JSP25-02 CAMELOT PARC TOWNHOMES LOCATION

City of Novi PSLR Concept Plan Presentation
March 23, 2026

PLANNING REVIEW

2nd Revised PSLR Concept Plan

Tree Mitigation

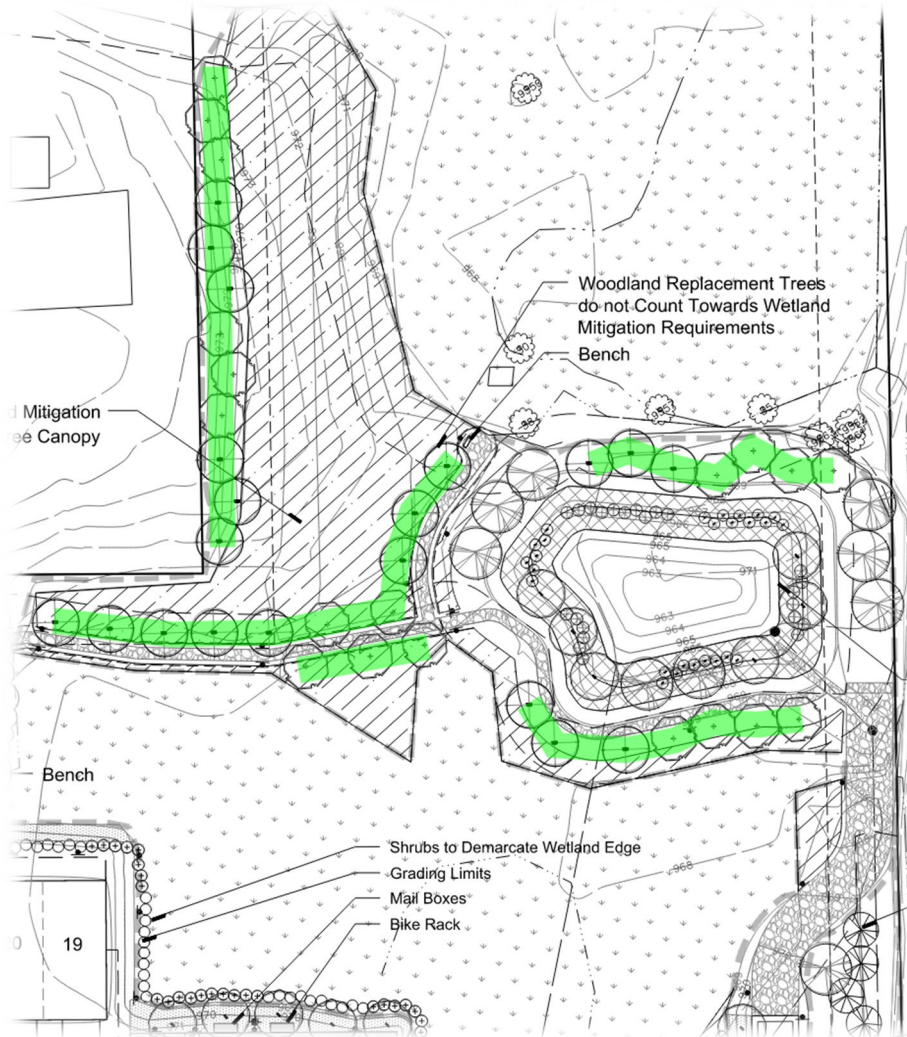
- The applicant has stated on Sheet L-1 that all trees will be replaced via a non-refundable payment into the City of Novi Tree Fund. The applicant should list on the site plan (where appropriate) that **all 43 replacement trees will be paid into the City of Novi Tree Fund via a non-refundable payment of \$17,200 (43 x \$400).**

- o **Requested Edit:** Sheet L-1 should be updated to reflect the number of replacements listed on Sheet 10. Note that not all removals of trees on-site are of regulated trees.

- Added 39 additional trees
- Revised calculations for allowable credits
- 0 trees remain to be paid into fund

VILLAS AT STONEBROOK PAVEMENT MAINTENANCE CONTRIBUTION CALCULATION

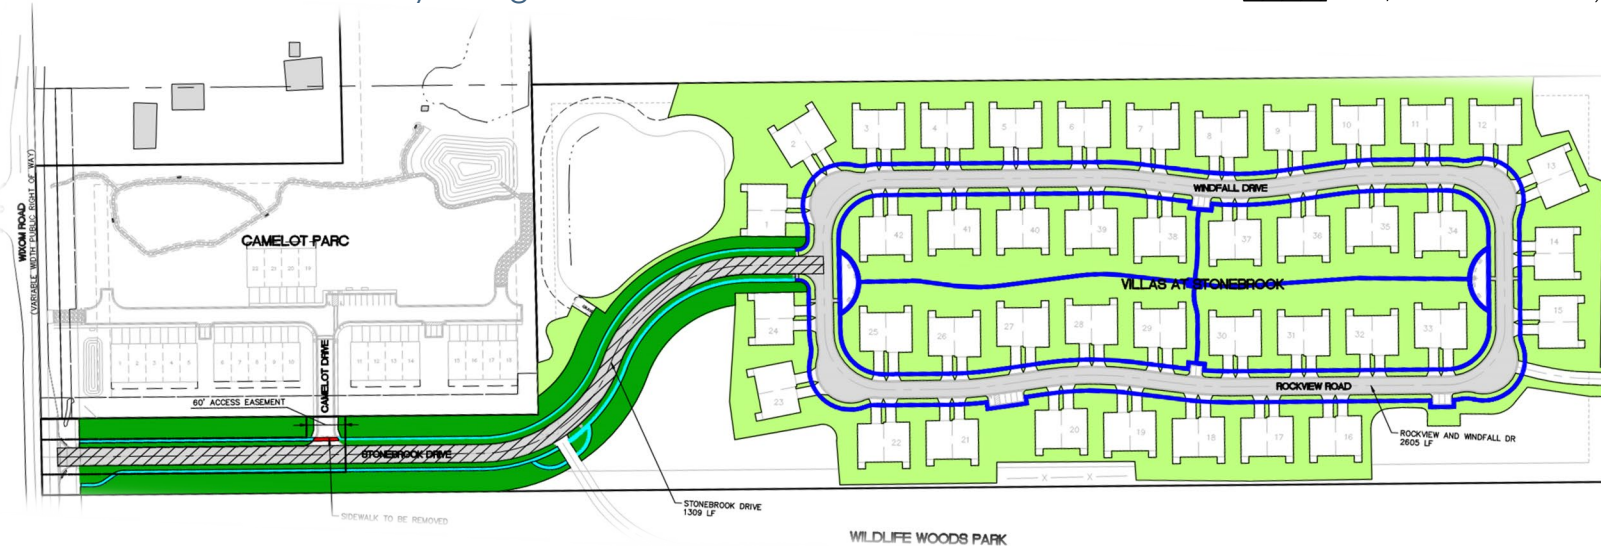
6. **Stonebrook Drive:** The applicant has included a proposed Road Maintenance Plan on Sheet 12 for Stonebrook Drive. The plan calculates a contribution for the proposed Camelot Parc toward Stonebrook Drive maintenance costs based on the length of the road, percentage of road used to access Wildlife Woods Park, and the total number of units for each development. **As Stonebrook Drive is a private road owned by Villas at Stonebrook HOA, the applicant has indicated they are discussing the road maintenance agreement with them. Any cost-sharing agreement would be a private agreement between the two entities.**

- Increased contribution to 25% by Camelot Parc toward shared area expenses
- Now includes entire length of Stonebrook Drive
- Added contributions toward lawn care, sidewalks and irrigation in addition to the roadway along the Stonebrook Drive corridor

AVALON PARK DEVELOPMENT, LLC
 CAMELOT PARC TOWNHOMES
 PSJR OVERLAY CONCEPT PLAN
 PRESERVATION AREA PLAN &
 HABITAT ENHANCEMENTS

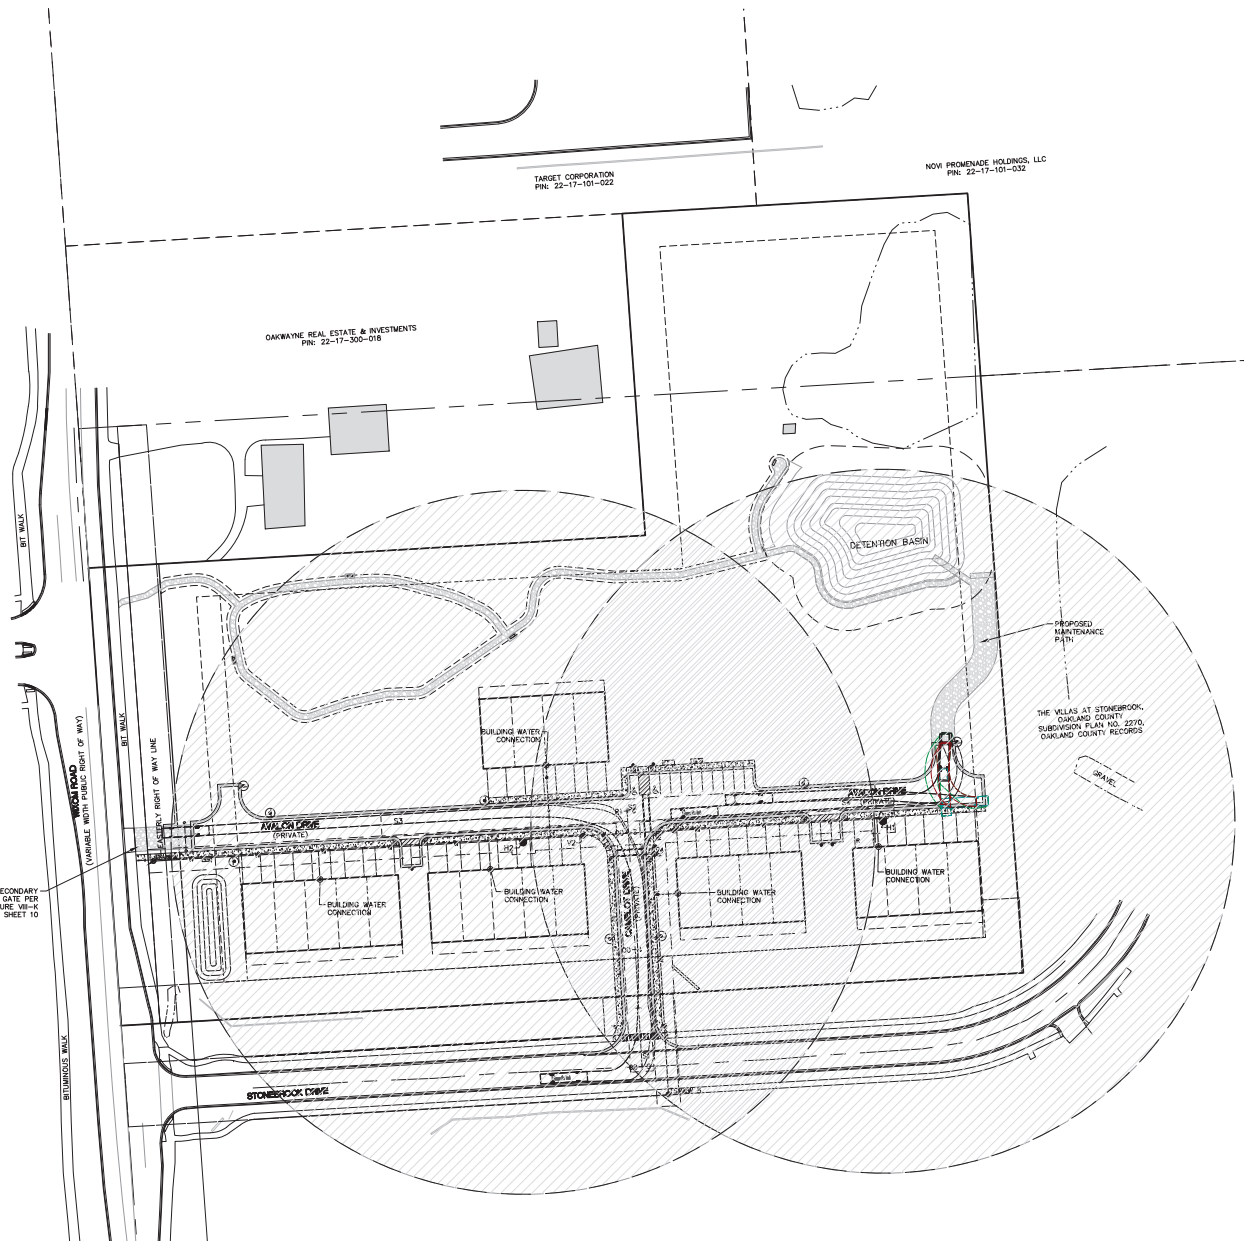
10. **Preservation of Natural Features:** Sheet 8 of the revised PSLR plan shows the area to be protected by preservation or conservation easements is 4.25 acres. Within this area the applicant indicates they will remove invasive species, sow native seeds to promote growth of desirable species, and place new habitat structures for wildlife.

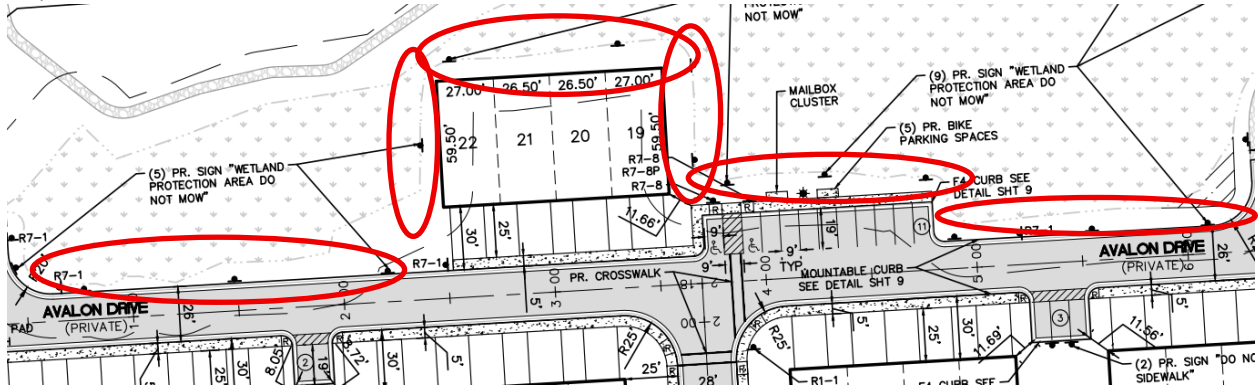
Impact	Amount
Forested Buffer	8,198 sq. ft. (0.19 acre)
Emergent Buffer	20,408 sq. ft. (0.47 acre)
Scrub-shrub Buffer	2,652 sq. ft. (0.06 acre)
Total Buffer Impact	31,258 sq. ft. (0.72 acre)

Requested edit: In future submittals, buffer impacts should be differentiated by permanent and temporary impacts (if applicable). If impacts are temporary, descriptions or sequencing should be provided showing how the temporary impacts will be restored. The temporary wetland restoration sequencing provided on Sheet 7 can be applied to any temporary buffer impacts – the header will need to be updated. Identify any temporary buffer impacts using a different symbology in the site plan.

Requested Placement locations

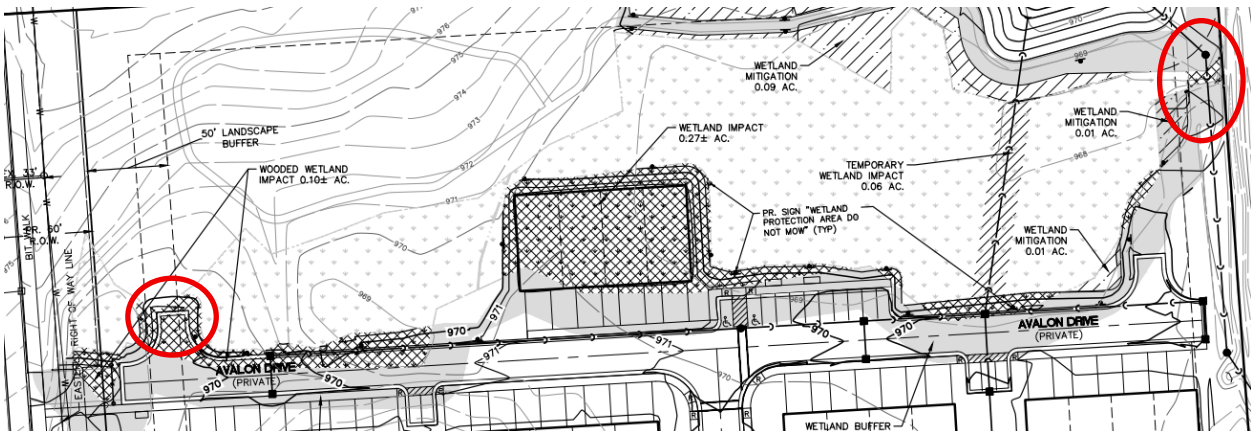
Due to the extensive proposed loss of wetland buffer along the southern remaining wetland area, it is requested that the applicant perform environmental enhancement along the southern portion of the remaining wetland (see screenshot below). The applicant should plant at least three different species of wetland rated shrubs throughout the southern boundary of the wetland. This will allow a small separation from the wetland and the proposed development. Additionally, it will deter any accidental mowing of the wetlands and remaining buffer areas. Shrubs could include three of the following species:

Figure 1. City of Novi Regulated Woodlands Map

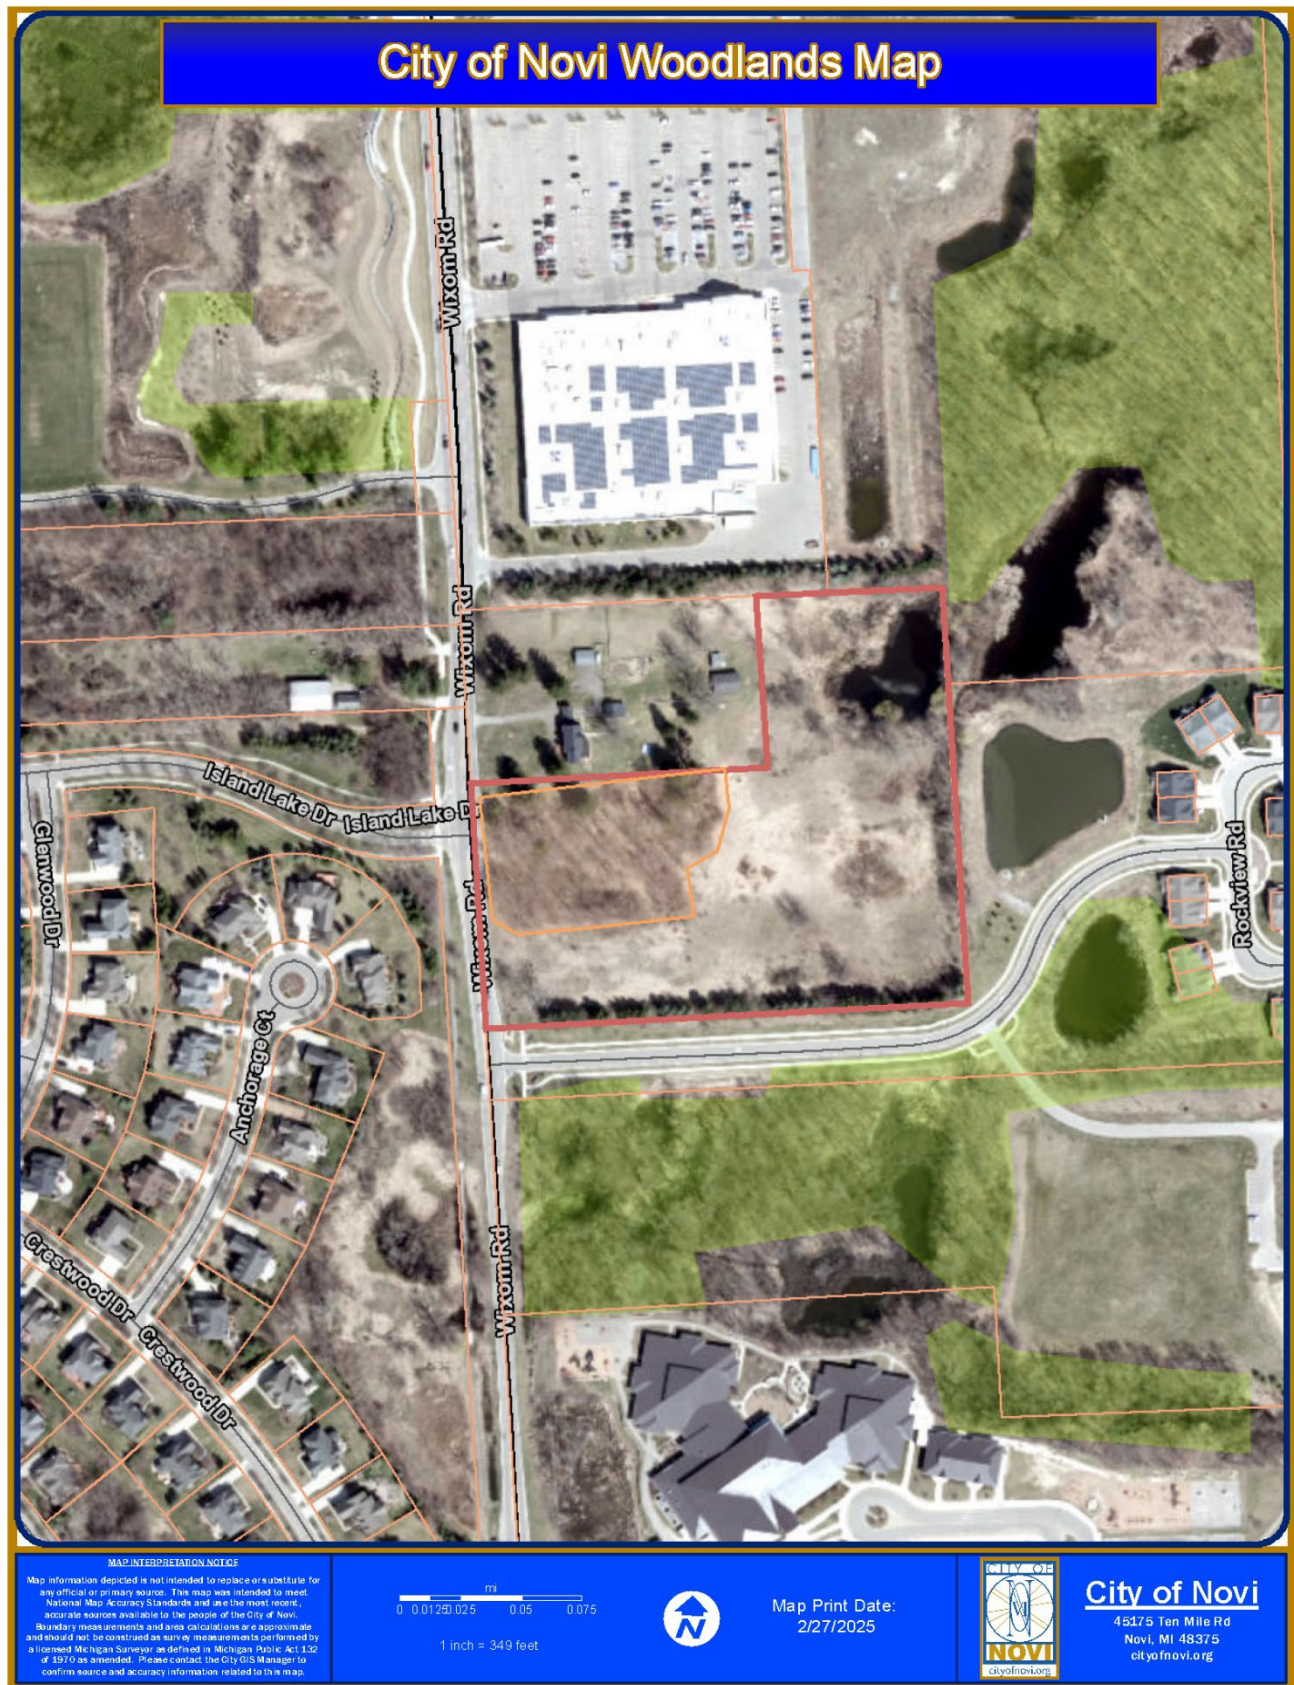
1. City-regulated woodlands, as identified on the City of Novi Woodlands interactive map website, are not noted as being present onsite. However, Merjent reviewed the JSP22-01 Woodland Review performed by DRG and concurs with DRG's establishment of regulated woodlands on-site. Note that both the woodlands and property limits depicted on the City map are considered approximations (**Figure 1**). Select photos from the site visit is included in **Attachment A**.
